Delegated Report

Householder Planning Application

Planning Application No: 20231164

Description: Construction of a dropped kerb and vehicle crossover.

Kent Design 'Making it Happen' Design Standards Page 26

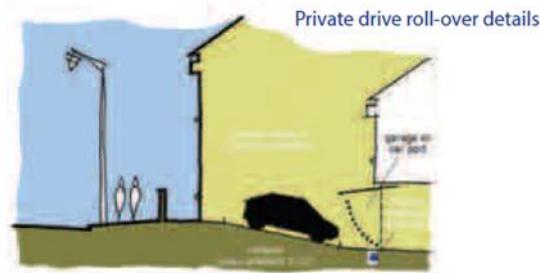
As we have previously discussed, due to site topography and levels present, there are concerns that the completed gradient may make the vehicle crossing difficult to use by some vehicles, which could result in vehicle contact with either the new crossing surface, the road or the boundary line at the front of your property. By accepting this quotation, you would also be accepting that neither Kent County Council or our contractor New Approach Contractors can accept any liability for any future damage caused to vehicles in its use

No long sections have been presented to demonstrate that a suitable gradient can be achieved resulting in a restriction on the use of the access by existing and future occupants. It is also noted that the property benefits from a rear access and the rear garden is more suitable place for parking vehicles. Generally a maximum gradient of 10% is considered acceptable, although a slightly steeper gradient may be achievable if suitable approaches and exits to the slope can be achieved, but this takes space, which does not appear to be available in this instance.

Given the loss of amenity space could set a precedent for further applications from neighbours, and there is no guarantee that the driveway would be useable, I would suggest refusal pending further information, it seems inappropriate that Kent County Council are not following their own adopted design standards.

Wherever possible driveways should incorporate shallow gradients or include roll-over details. (see opposite). Drivers will have less control of their vehicle's speed on steeper gradients, which could result in accidents.

Private Drive Roll-over details

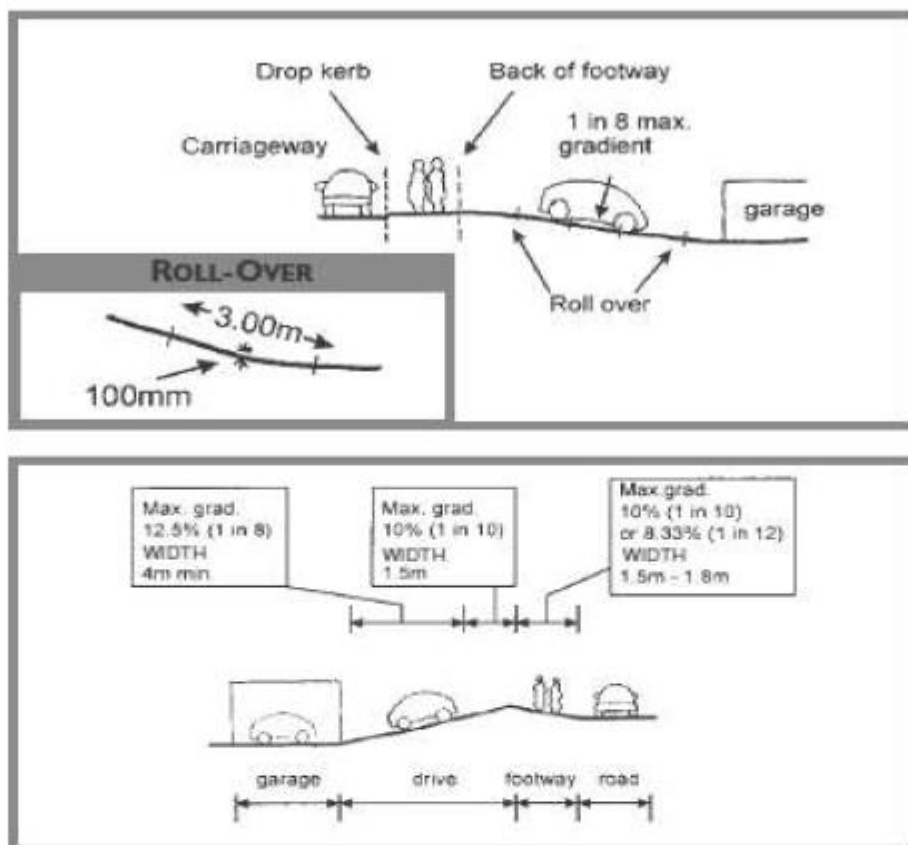
In this case both the Council's Highways Officer and KCC Highways advise that the application should be refused on account of the access being too steep i.e. greater than 1 in 10 and so would not meet the KCC vehicle crossing criteria. The crossover could potentially lead to vehicles slipping into the carriageway during icy weather which would be detrimental to highway safety.

The proposed crossover by virtue of its steep gradient would be unacceptable as it could potentially lead to vehicles slipping into the carriageway during icy weather which would be detrimental to highway safety. As such the proposal would be contrary to Policy CS11 (LPCS), saved Policy T5 (LPFR), section 11 of the NPPF (2023) and would not adhere to the guidance as set out in the Kent Design Guide making it happen –

Shared and individual private drives should not normally have a longitudinal gradient steeper than 10% (1 in 10). However, access gradients may be increased to a maximum of 12.5% (1 in 8) on sites where the level differences make it impractical to use less steep gradients.

To prevent vehicles from grounding, the gradient must be maintained at 10% (1 in 10) for a distance of at least 1.5m from the back of the highway boundary, or include a roll-over detail as shown below.
